IRC Rule Changes for 2026

IRC Technical Committee

This Version: 17 September 2025

8. A7 - MAINSAIL MEASUREMENT DEFINITIONS

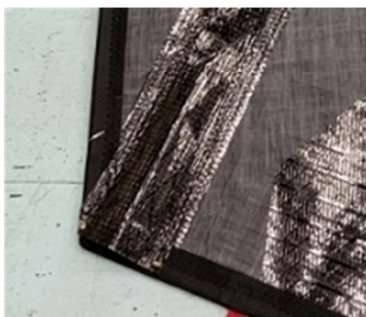
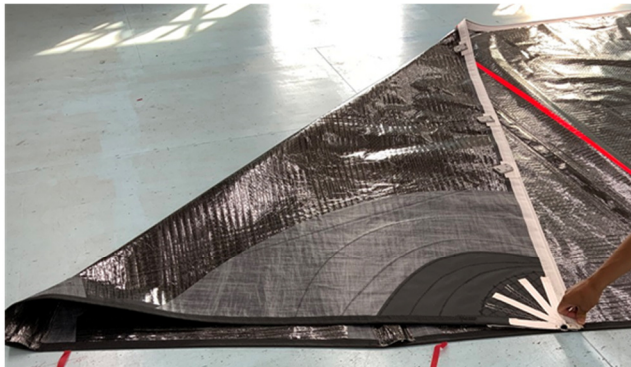
Reason for change: It has been noted that on some square top mainsails the Seven-Eighths Leech Point may be found on the head rather than the leech of the sail as shown in the pictures below:

Whilst it is noted that the number of sails that this will impact is low, it is proposed that an equivalent rule / requirement is added to the IRC Rules for 2026. This will have the additional benefit of making the MUW measurement consistent between IRC & ORC for all sails which will simplify the labelling of sails using the UMS measurement stickers.

MUW The maximum permitted **mainsail seven-eighths width**. **If a seven-eighths leech point cannot be found on the leech, the aft head point shall be taken as the seven-eighths leech point.**
